**Remedial Investigation and  
Feasibility Study Work Plan  
Revision 2**

Nevada Environmental Response  
Trust Site; Henderson, Nevada

*Date:*  
**June 19, 2014**

Plate  
**2**

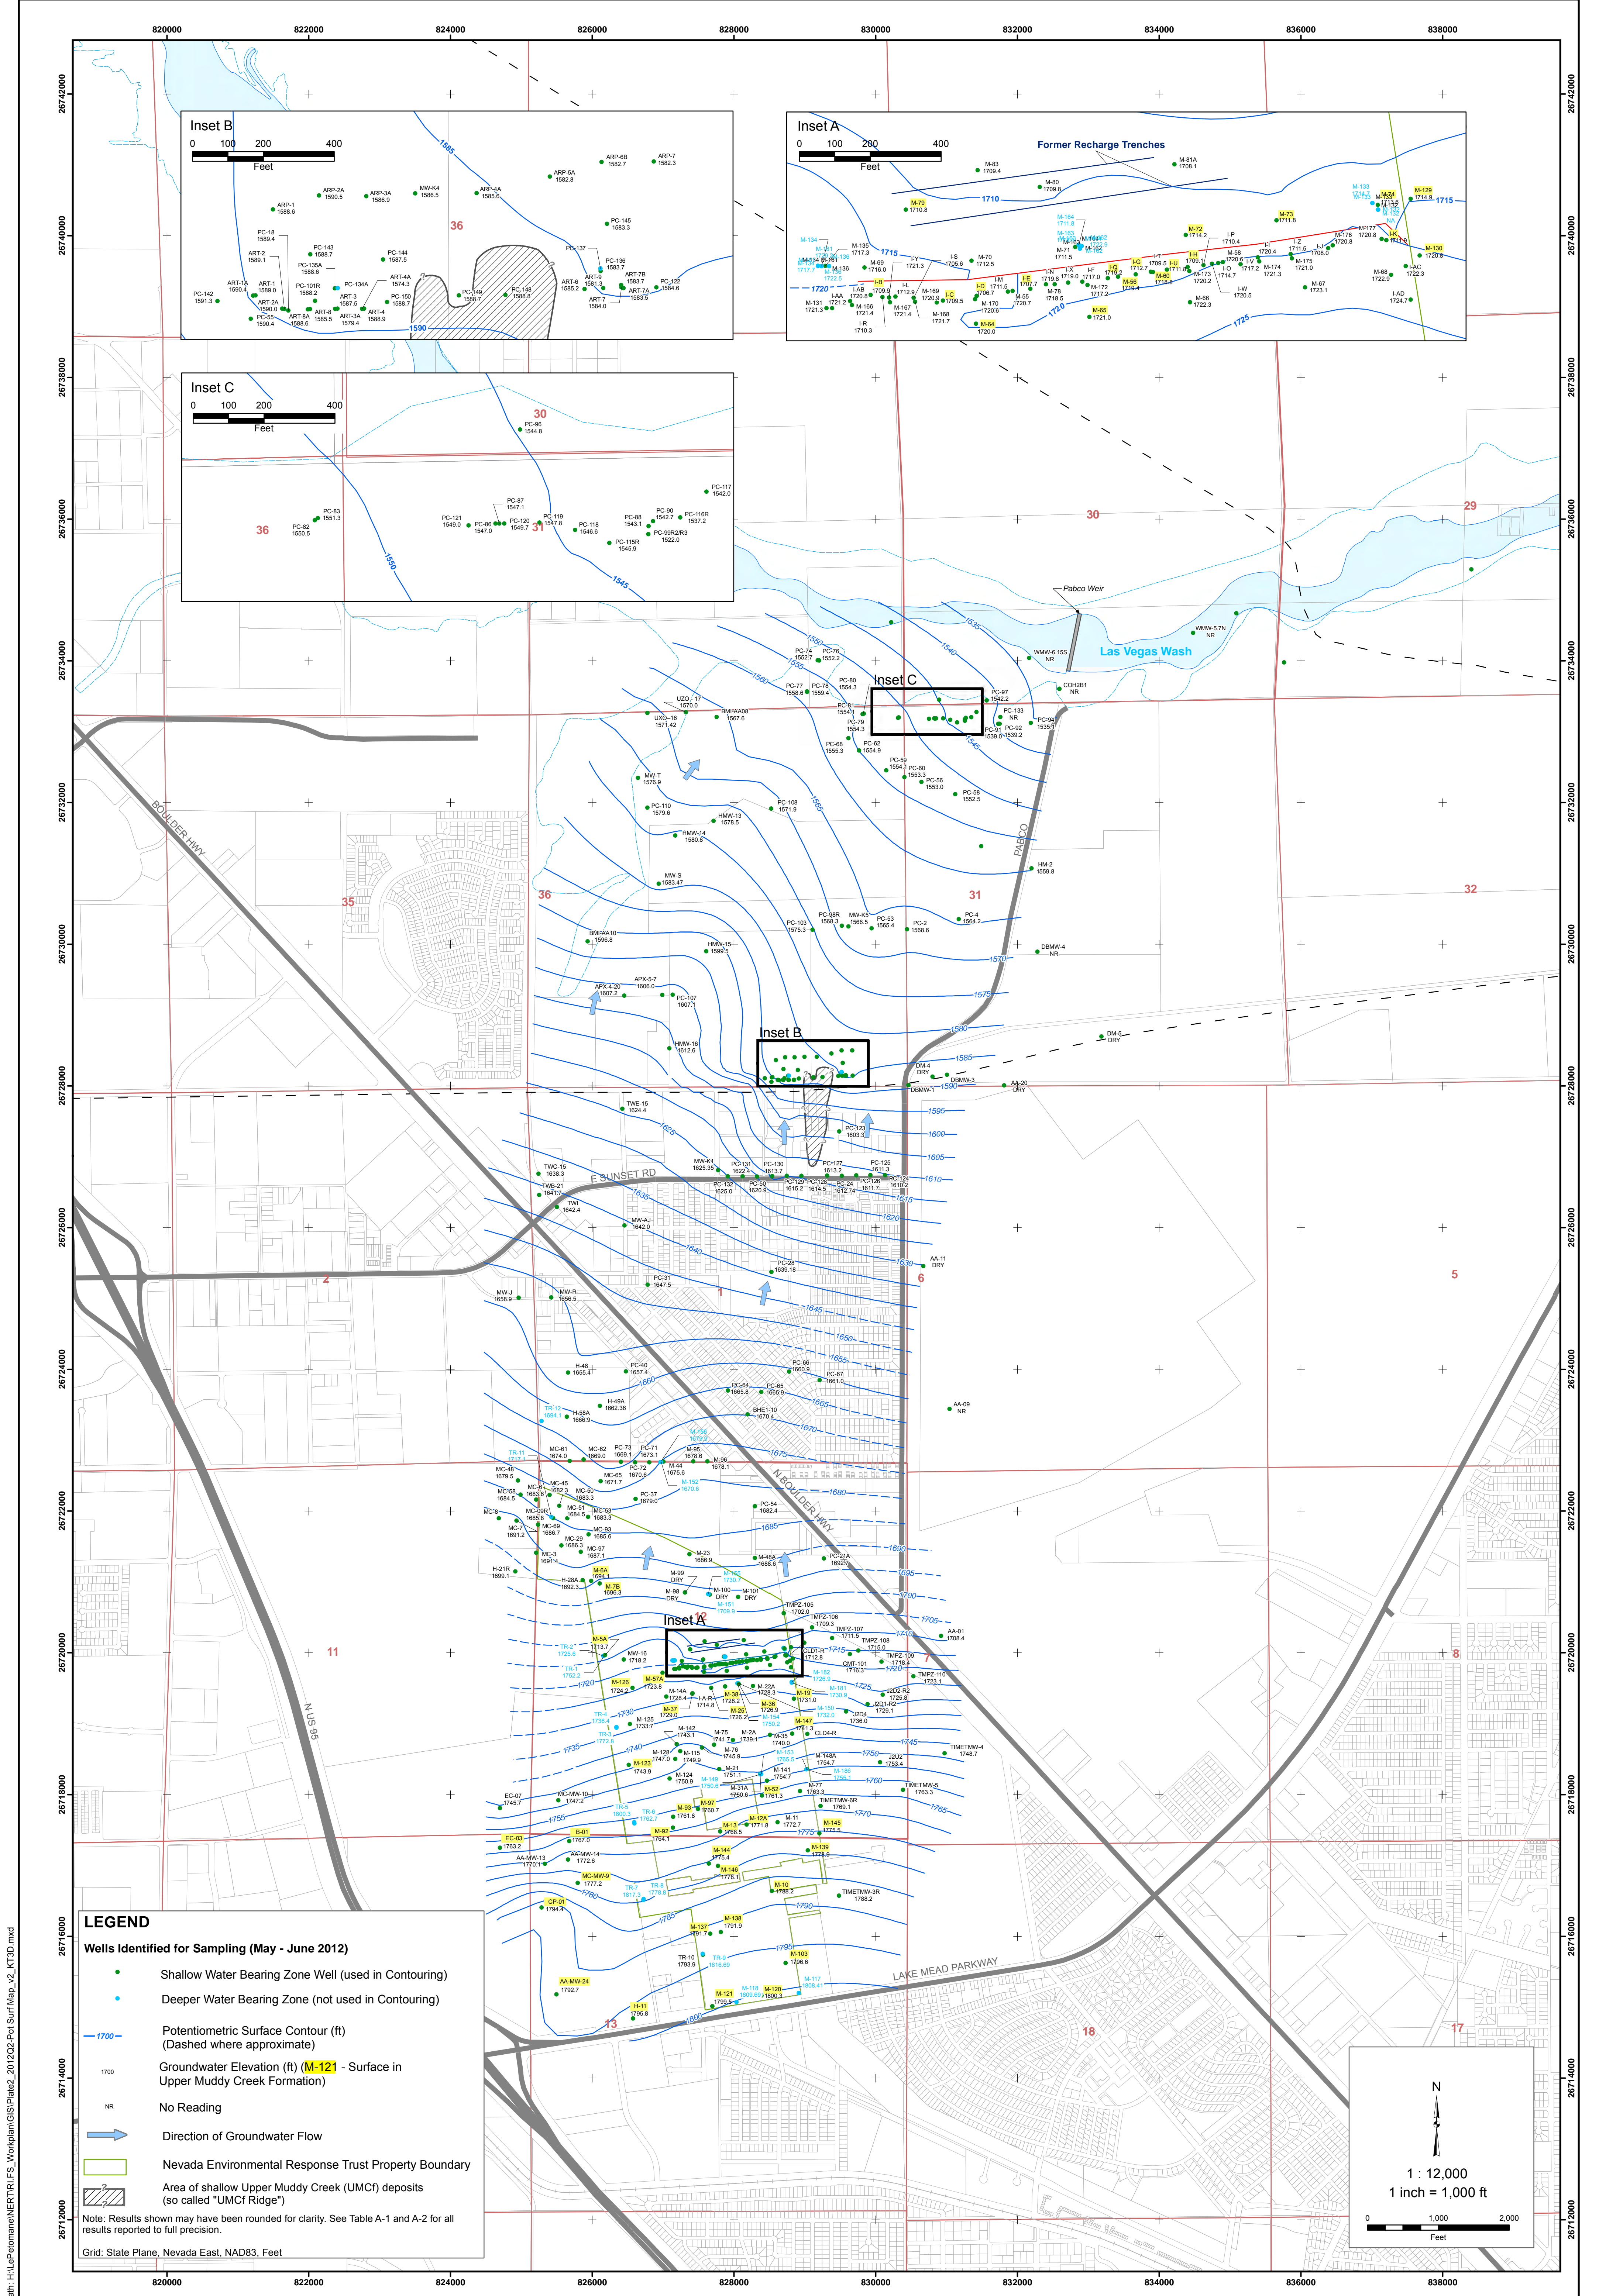
81. Plate 2 Potentiometric scaling: Gradients are flatter below the COH Bird Viewing Ponds, possibly due to higher hydraulic conductivity. This needs to be examined in more detail to optimize perchlorate capture while reducing pumping in the SWF area. It is assumed that the SWF wells are partially capturing Las Vegas Wash water, but possibly they are capturing City of Henderson (COH) waste water effluent in the downgradient SWF wells also. Examination of major or trace ion data might be an approach to this issue.	The question of how much surface water is being captured by the SWF will be examined in more detail as part of the GWETS Optimization Study. Results of this analysis will be incorporated into the RI/FS as they are developed.

**GROUNDWATER TOTAL CHROMIUM MAP  
SHALLOW WATER-BEARING ZONE  
SECOND QUARTER 2012**

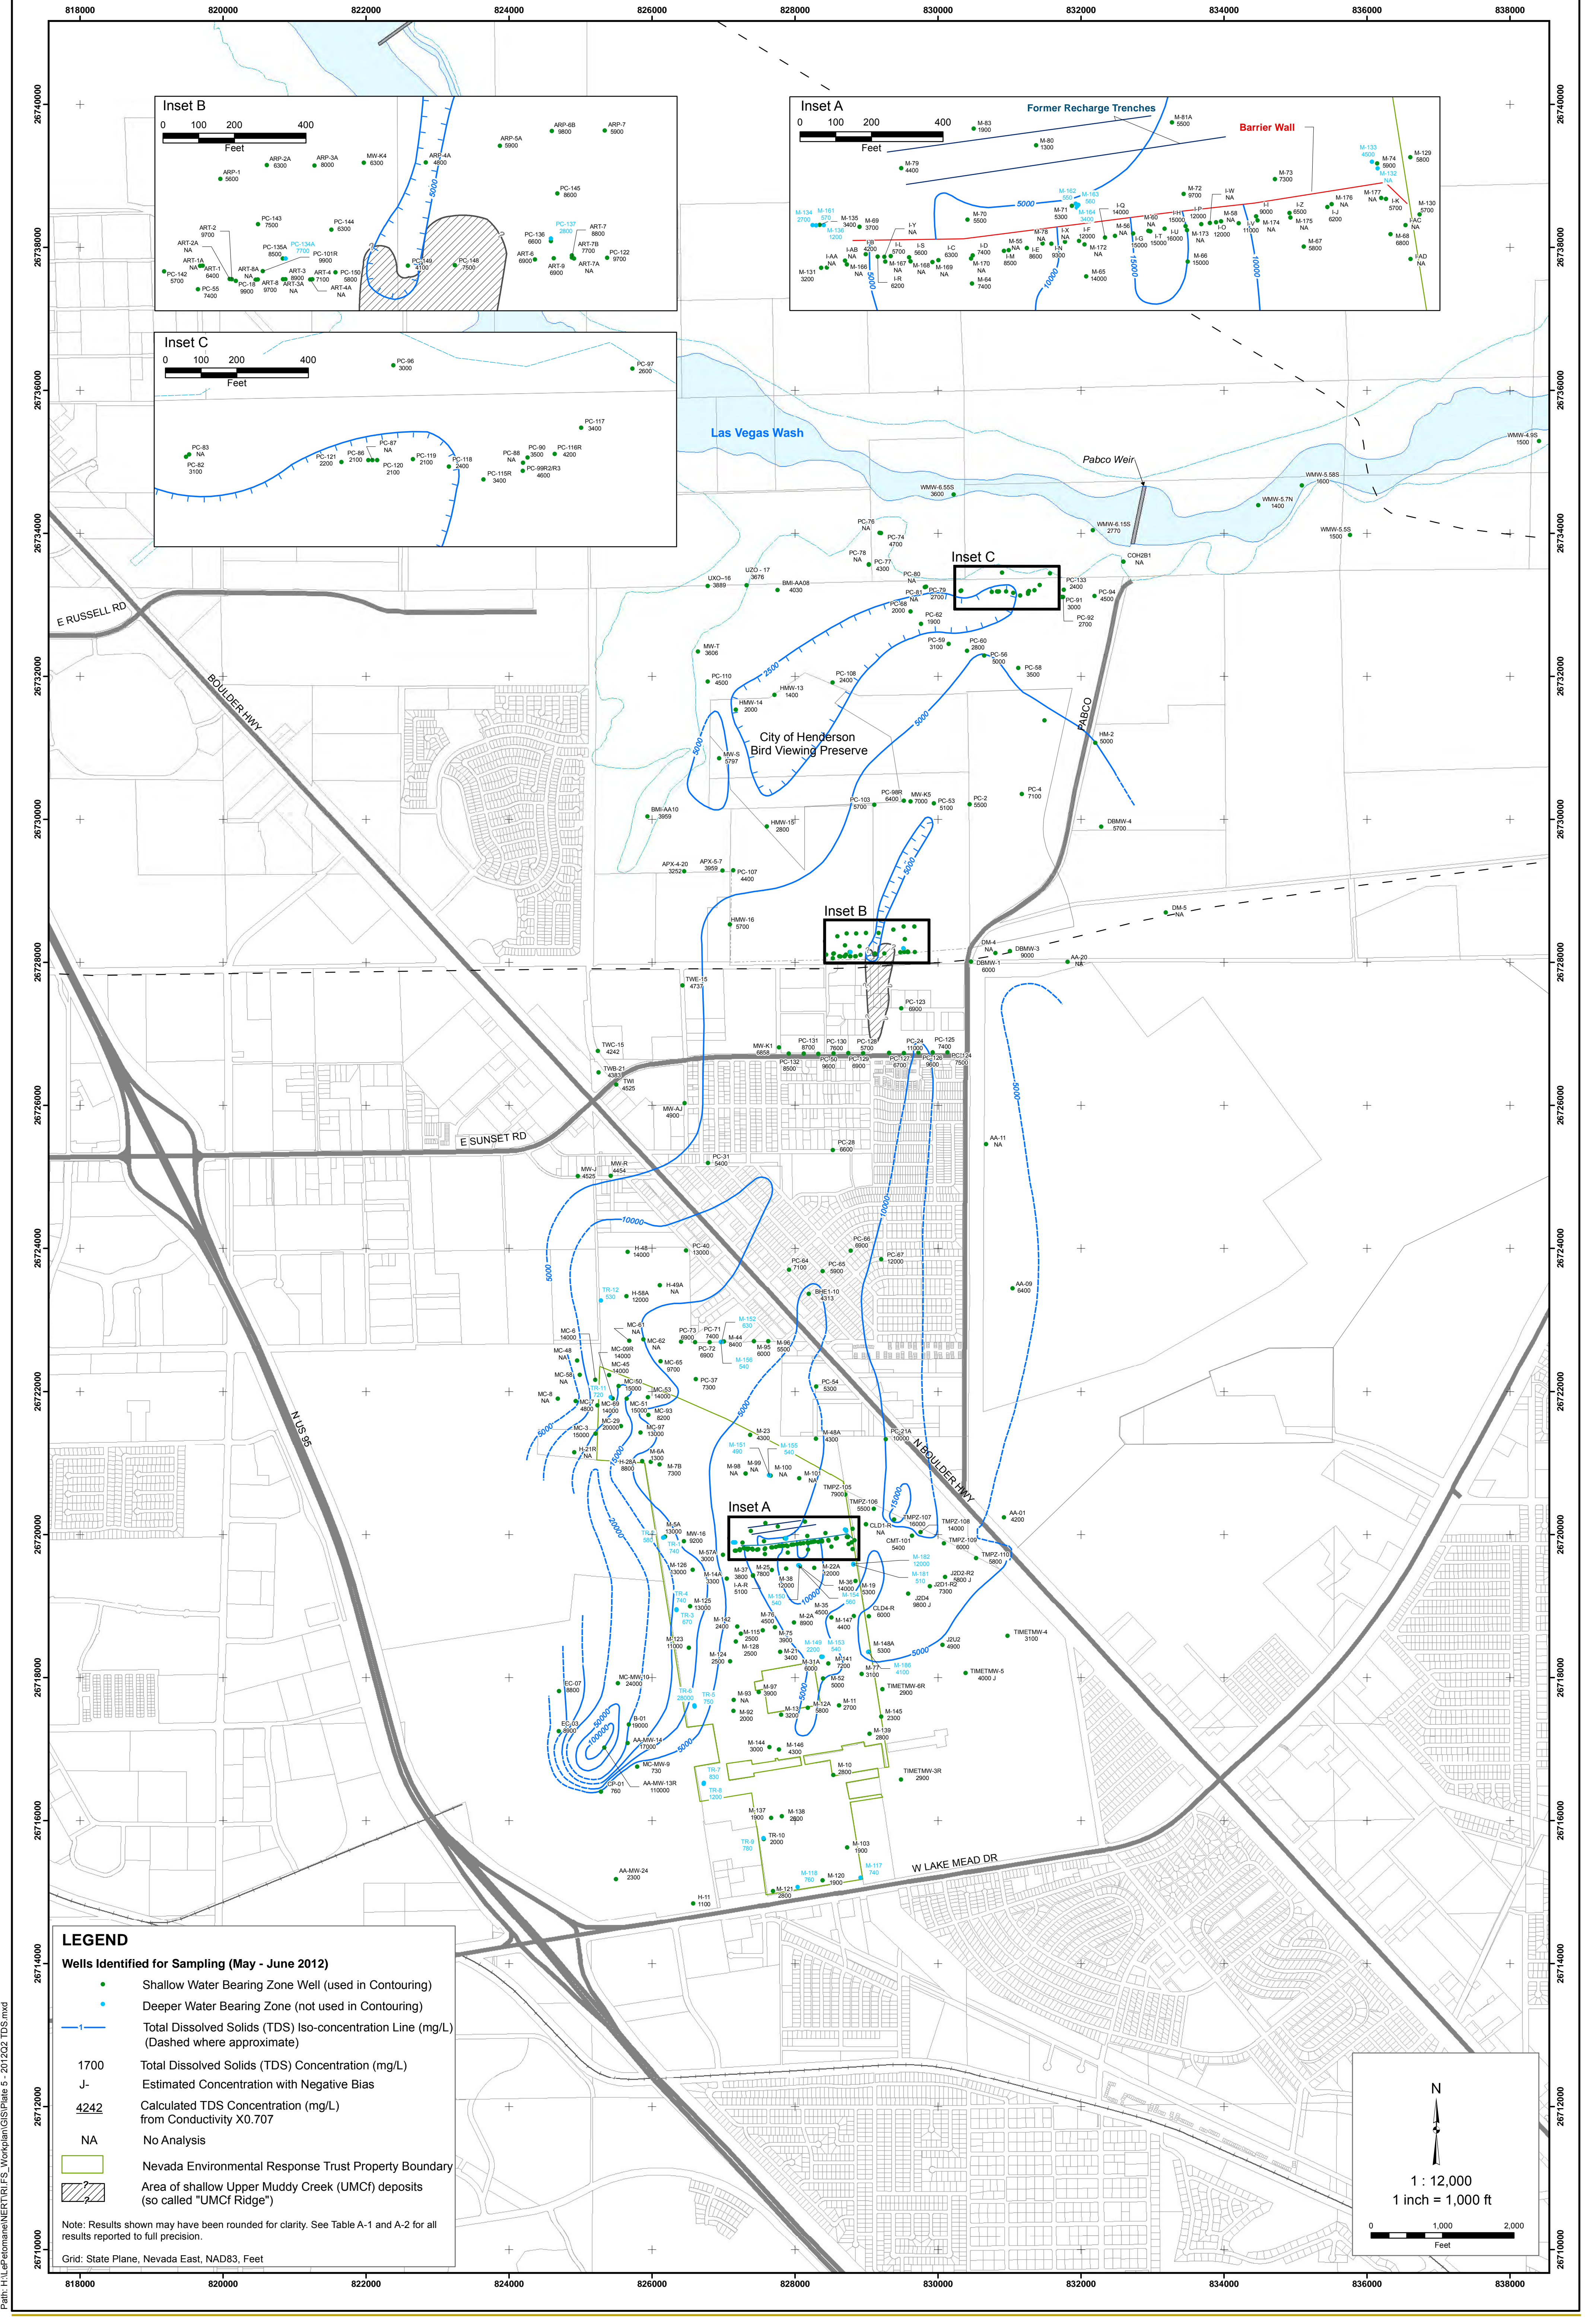
82. Plate 4 shows WMW5.7N as containing "< 3 mg/L", which is correct; but actual values are probably much lower. For example, WMW5.8SI is something over 200 µg/L. These need to be depicted in more detail to help understand the conditions near the Pabco Weir. TDS is similarly too grossly scaled, showing nothing < 5000 mg/L.	The maps were developed using data available at the time. As part of preparing the revised RI/FS Work Plan, additional data will be sought from the Southern Nevada Water Authority (SNWA) and others as appropriate in order to refine the interpretations in this area.

83. Plate 4 Groundwater Total Chromium Map, Shallow Water-Bearing Zone. The Call-out maps shows the perchlorate concentrations instead of the total chromium concentrations.	This will be corrected in the revised RI/FS Work Plan.
